Re: Village of Hoffman Estates
Village Green Concessions
Architect's Project Number: 24-002
Addendum #3

ADDENDUM #3

September 27, 2024

2 FOOD SERVICE HOOD - ANSUL SYSTEM CONTROL DETAIL
E5.01 NOT TO SCALE

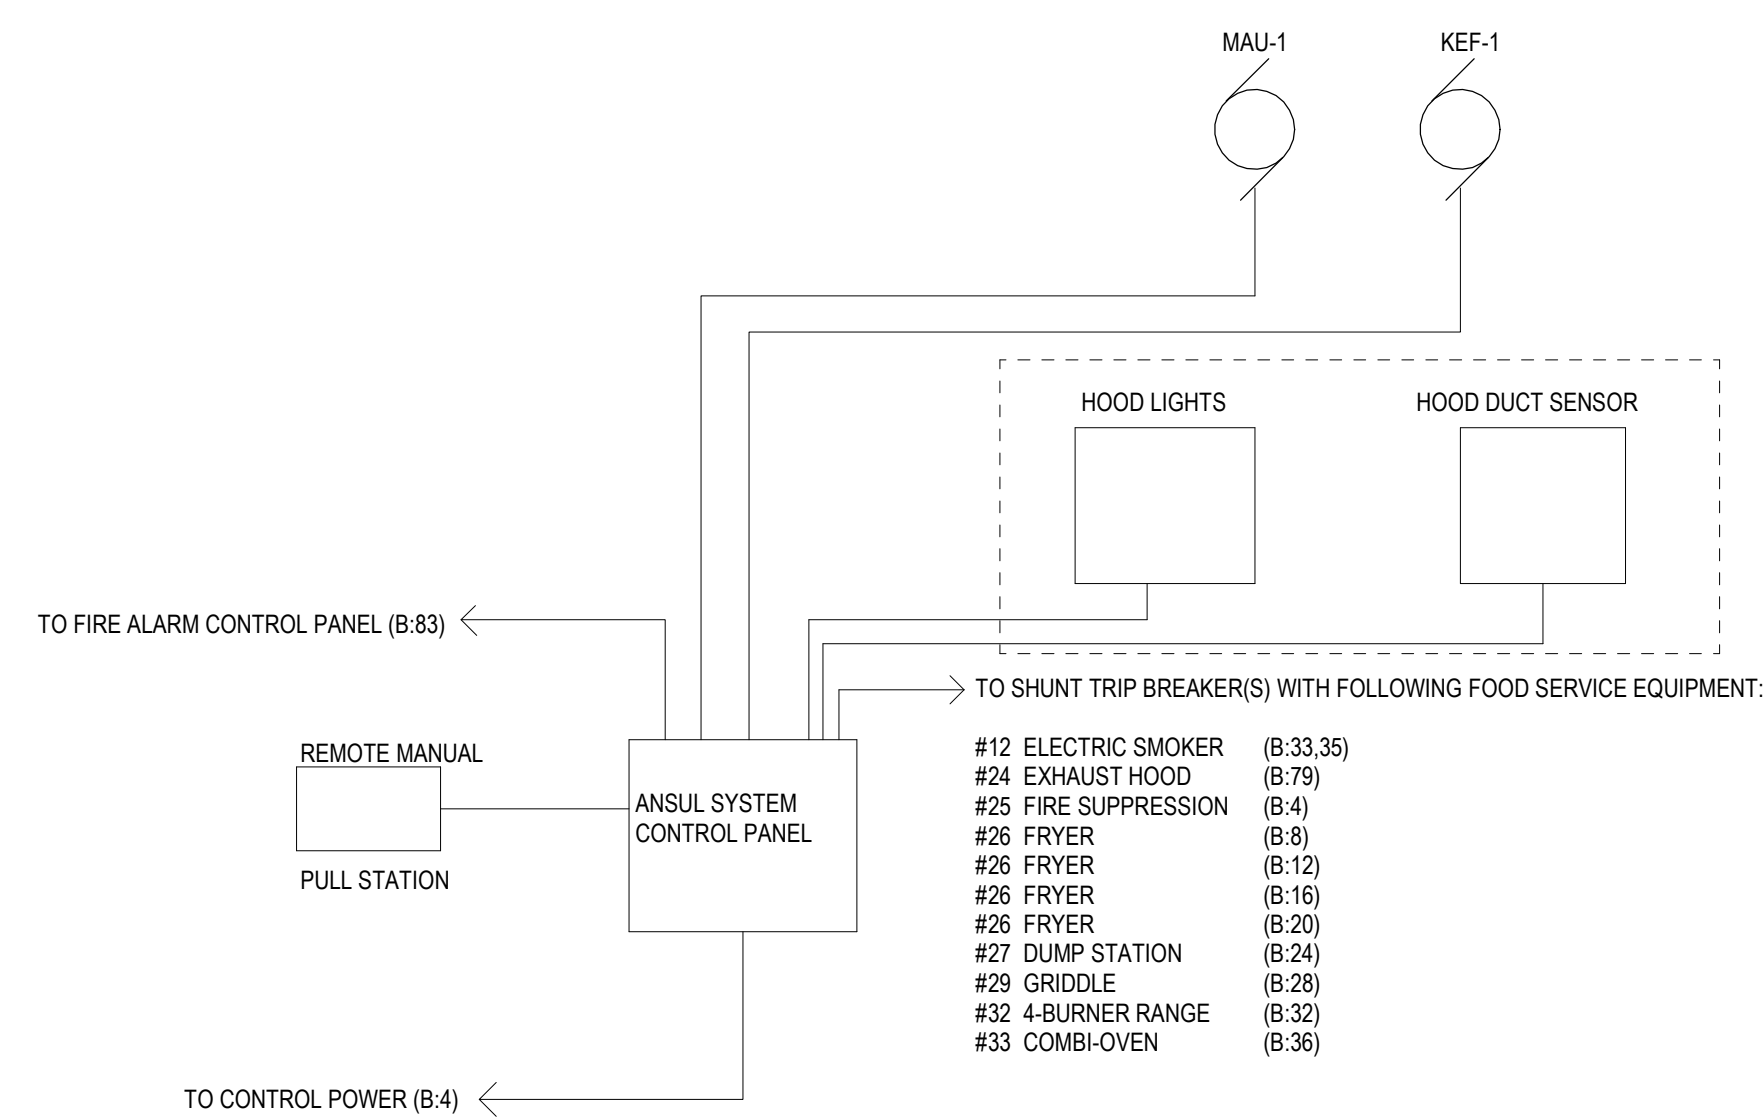
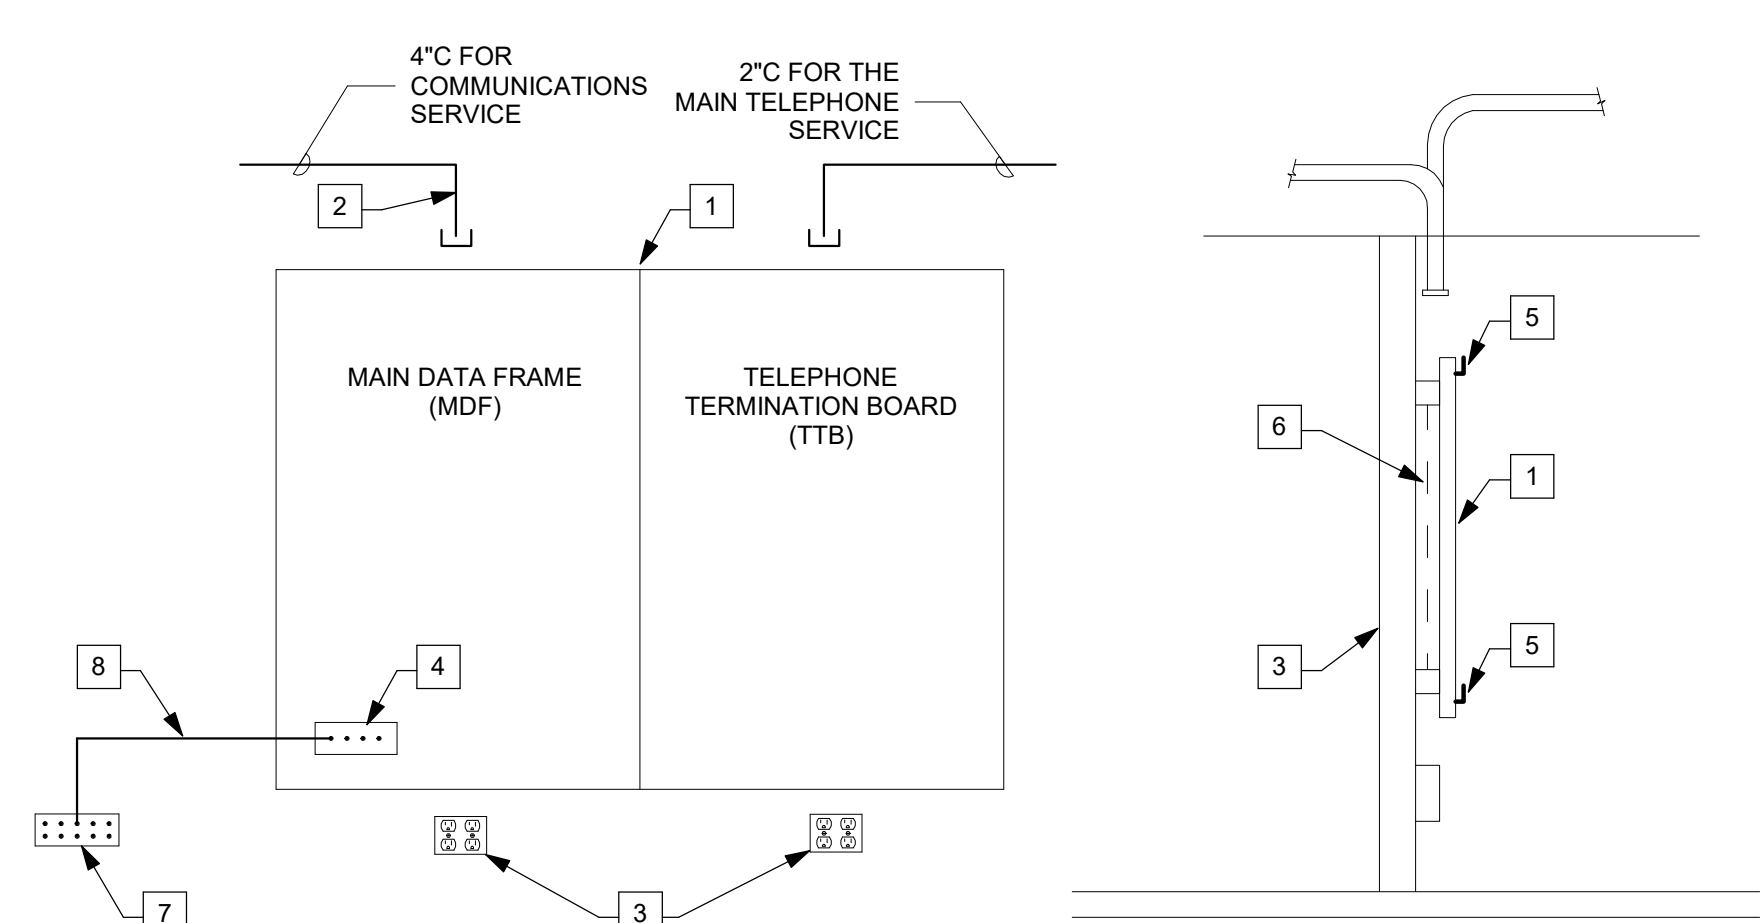
ANSWER: They can be provided at the panel or at the device. Added note #15 to attached replacement Sheet E1.00 above.
16. QUESTION: Shunt trip is required at kitchen hoods per NEC. Please ask the electrical engineer to provide a detail or specification for shunt trip and GFCI protection at the hoods.

ANSWER: Added a shunt space in Panel 'B' for all equipment under the hood. Added a new sheet – E5.01 with the shunt trip/hood detail.
17. QUESTION: Panelboard specification 26 24 16 calls for flush mounted panelboards. Please note that the existing reused panelboard will not be able to be installed flush in the CMU wall. Should the gypsum board partition where the new panelboards are show to be mounted be increased in thickness to allow for flush installation of panelboards?

UNDERGROUND CONDUIT DETAIL FOR BEER LINES
SCALE: NOT TO SCALE

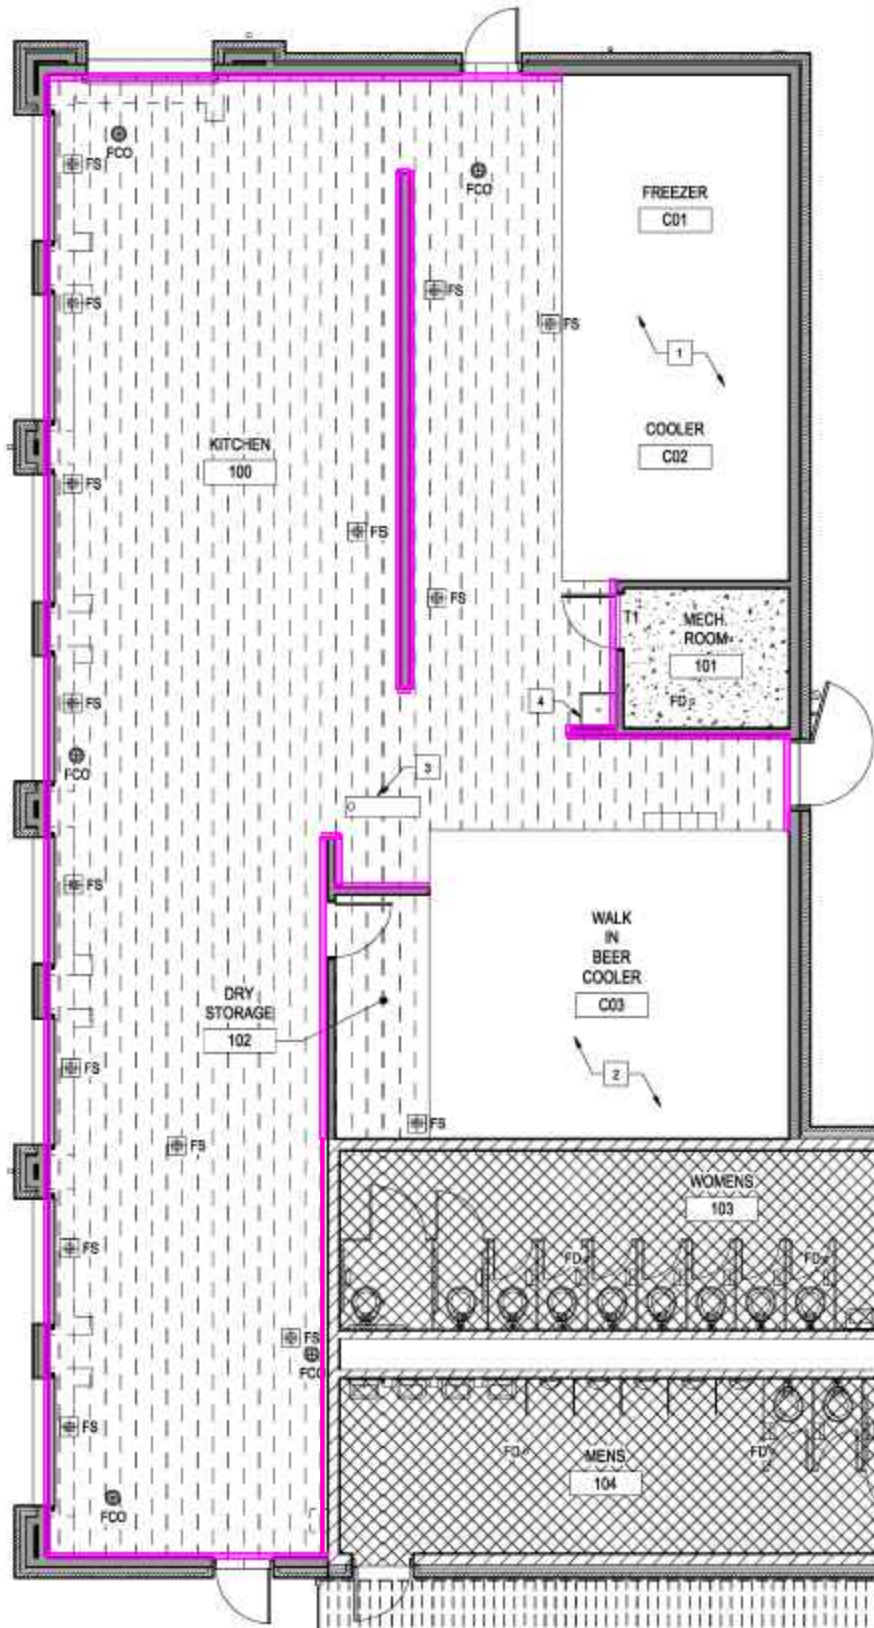
- b. **REPLACE** Underground Conduit detail with attached ASK-03.
8. Drawing S1.00 – **REPLACE** with attached S1.00 to revise as follows:
 - a. Revise elevation of interior footing at grid C-3.2 to -1'-0".

8. QUESTION: Who is responsible for providing and installing the underground beer lines from the power packs to the beer heads? This is on the FS.4 drawing. The drawings don't state who is responsible for this work.

ANSWER: General Contractor is to provide the beer line chases for the beer systems - refer to attached replacement detail ASK-03 for sizes of conduit pipe. The KEC is to provide the labor and material for the beer lines and pull them through the chases.

LOCATION OF FRP
SCALE: NOT TO SCALE

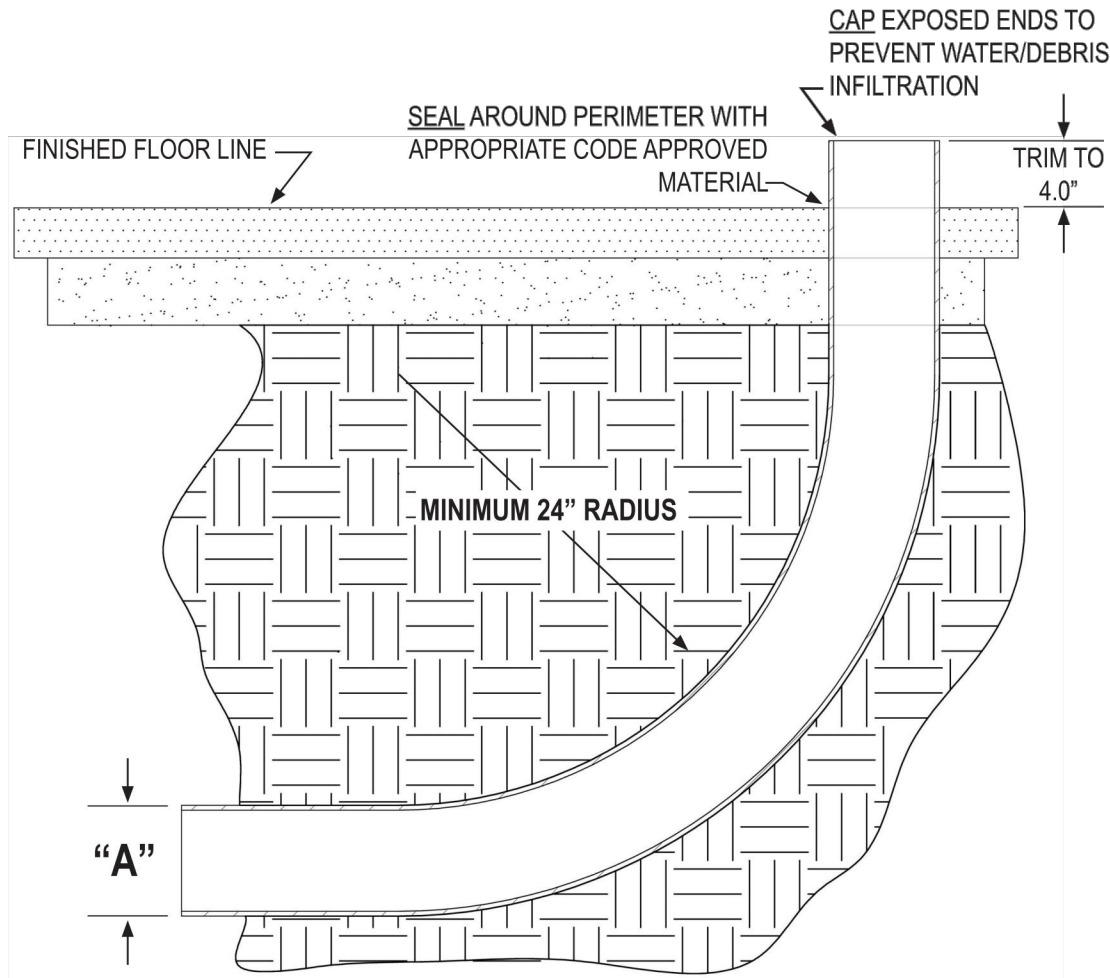
ANSWER: The note has been removed since the proposed finished grade will be similar to the existing surface elevation.
10. QUESTION: Can the extent of FRP please be clarified? Finish schedule state FRP on all wall in the kitchen. Does the FRP go on the freezer and walk in beer cooler's walls?

ANSWER: Refer to attached ASK-02 for extent of FRP.
11. QUESTION: The schedule shows NTP September of 2025, is there potential to start the project earlier or are there issues that will prevent this?

FRP LOCATION IN KITCHEN - HIGHLIGHTED IN MAGENTA, INCLUDING MASONRY BACKED WALL.
